Access Compliance Report

Public Rights-of-Way

Intersection ID: 8316	Main Street: STATESVILLE_AV	Cross Street: NORTHERLY_RD	Location: NE
ADA ID: 3B133CCAB487	Ramp Type: BlendTrans1	Initial Pass/Fail: Fail	Overall Compliance: No
		Severity Score: 8.75

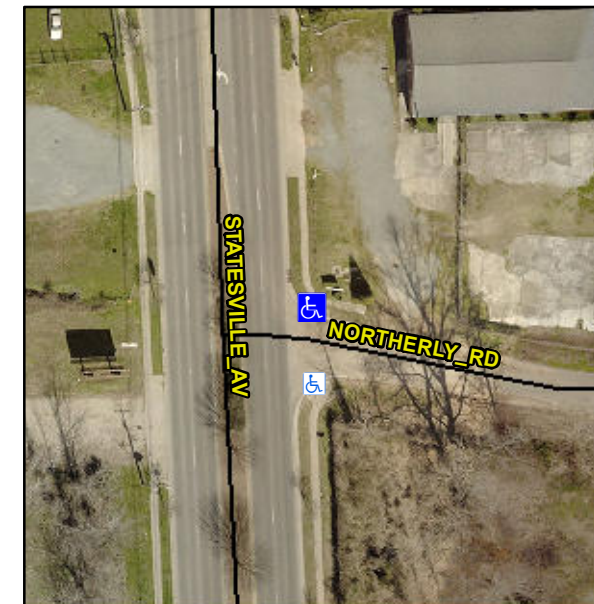
Not Found, R304.5.1

Compliance	Description	Data	Compliance	Description	Data
N/A	Ramp Length (in)	59.0	Yes	BlendTrans Slope (%)	3.4
No	Ramp Width (in)	37.0	Yes	BlendTrans XSlope (%)	0.2
N/A	Flare Type LT	N/A	N/A	Flare Type RT	N/A
N/A	Flare Slope LT (%)	N/A	N/A	Flare Slope RT (%)	N/A
N/A	Flare Traversable LT?	N/A	N/A	Flare Traversable RT?	N/A
N/A	Landing Length (in)	N/A	N/A	DWS Provided?	N/A
N/A	Landing Width (in)	N/A	N/A	DWS Contrast?	N/A
N/A	Landing Slope (%)	N/A	N/A	DWS Length (in)	N/A
N/A	Landing X Slope (%)	N/A	N/A	DWS Full Width?	N/A
N/A	Landing Curb? (Y/N)	N/A	N/A	DWS Offset (in)	N/A
N/A	Shared Landing?	N/A			
N/A	Gutter Ponding?	N/A	N/A	Gutter Slope (%)	N/A
N/A	Gutter Lip Ht (in)	N/A	N/A	Gutter X Slope (%)	N/A
N/A	Painted X Walk1?	No	N/A	Painted X Walk2?	N/A
	X Walk 1 Direction	To S		X Walk 2 Direction	N/A
	X Walk 1 Width (in)	N/A		X Walk 2 Width (in)	N/A
	X Walk 1 Slope (%)	0.7		X Walk 2 Slope (%)	N/A
	X Walk 1 X Slope (%)	0.4		X Walk 2 X Slope (%)	N/A

N/A	Ramp inside XWalk1?	N/A	N/A	Ramp inside XWalk2?	N/A
	Road Slope (%)	0.4		Clear Space?	N/A
	Road X Slope (%)	0.7	N/A	Clear Space to XWalk (in)	N/A
N/A	Any Obstructions?	N/A	N/A	Storm Grate/Utility Hazard?	N/A
	Obstruction Type			Storm Grate/Utility Type	
		N/A			N/A
			Yes	Surface Condition? (G/P)	Good
			No	Curb Slope (%)	21.1

Remove & Replace Curb Ramp With Two New Directional Ramps or Equivalent.
